Comments

ON THE REVISION OF THE COMPUTER REGULATION (EU) NO 617/2013

Following the Ecodesign and Energy Labelling Consultation Forum (X03609) on Computers of 19/03/2024, the environmental NGOs and repair actors represented by the Right to Repair Europe coalition, the Coolproducts campaign, ECOS, HOP, the EEB and DUH, hereby submit their views on the proposed refinements.

Figure 1: Sleep mode distribution from MAEDBs (California Energy Commission, 2024)

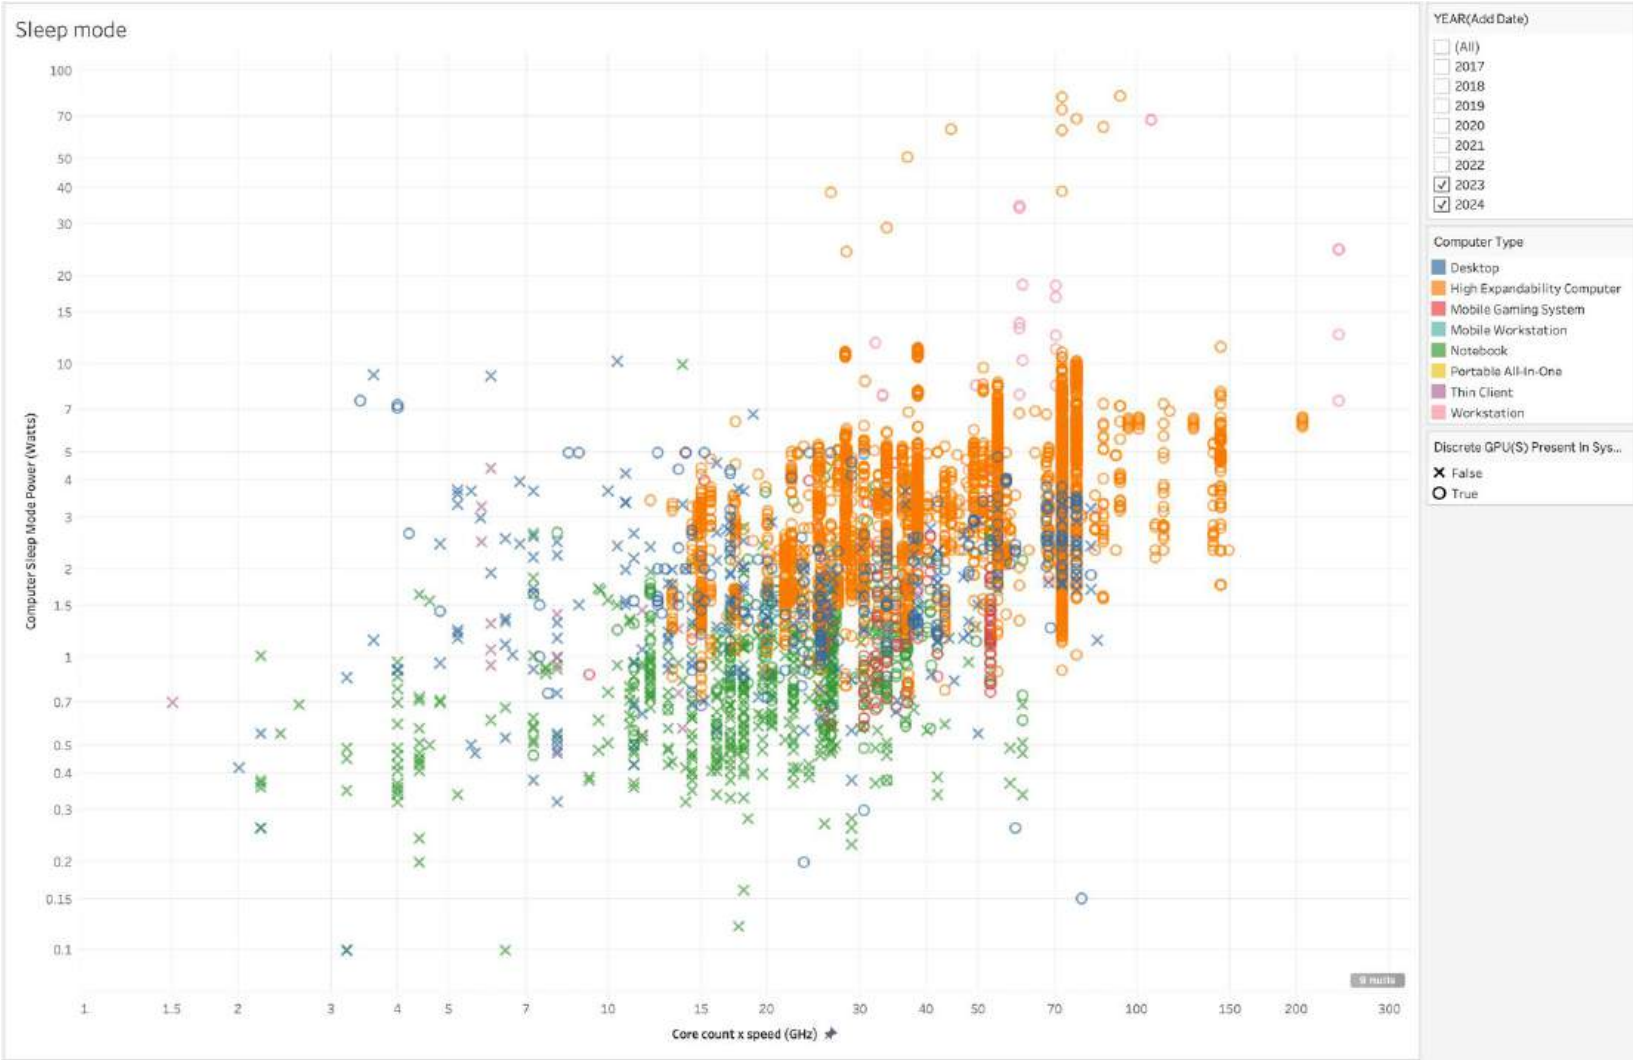
The California Energy Commission MAEDBs shows that for products registered in 2023/24, there is a significant difference in the sleep and idle powers (see Annex I), which correlates with CPU core count clock speed, external GPU and computer form factor. Figures 1, 2 and 3 (see Annex I) are plotted on a logarithmic scale because power and performance between computer types vary by around 1 to 100 times. This illustrates the inadequacy of a one-size-fits-all approach.

Laptops with integrated graphic cards are the largest market by volume of sales but the proposed requirements would have very little impact on these products. We recommend reducing the requirements for laptops without external graphics cards to:

- Sleep mode: 1W
- Long idle: 3W
- Short idle: 6W

- Focus idle and sleep requirements on product types where most impactful (e.g. laptops with integrated graphics) and tighten ambition to ensure that installed external graphics must always be inactive in long idle and sleep.
